**PCN#20181205001.0A**

**Pin One Dot Symbolization change – Adding Pin One Dot for Select ~~SC70~~, SOT-23,  
and SOT-223 Devices  
Information Only**

Current Symbolization (No Pin One Dot)	New Symbolization (With Pin One Dot)
SC70 Example		
SOT-23 3 Lead example		
SOT-23 5 Lead example

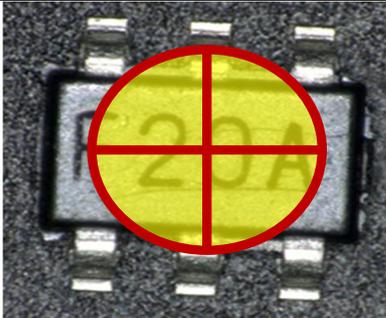
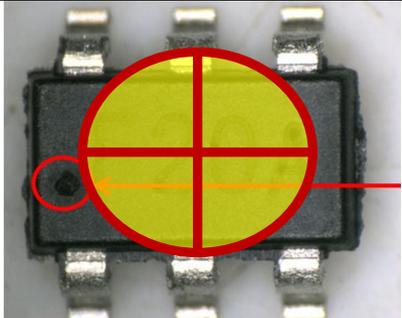
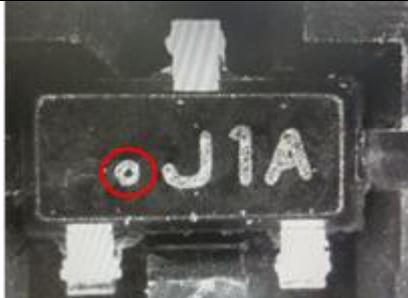
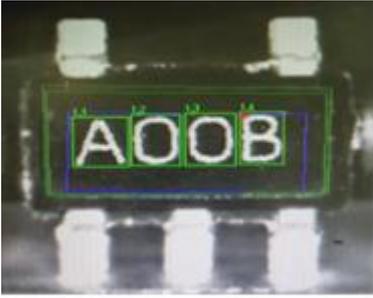
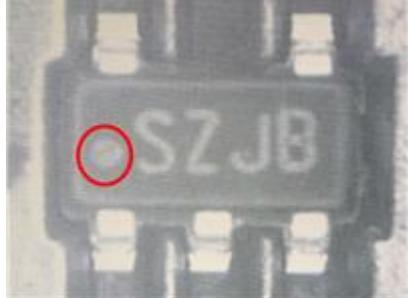
This letter is to inform of the addition of a Pin One dot in the devices symbolization of select **SC70**, SOT-23, and SOT-223 Devices:
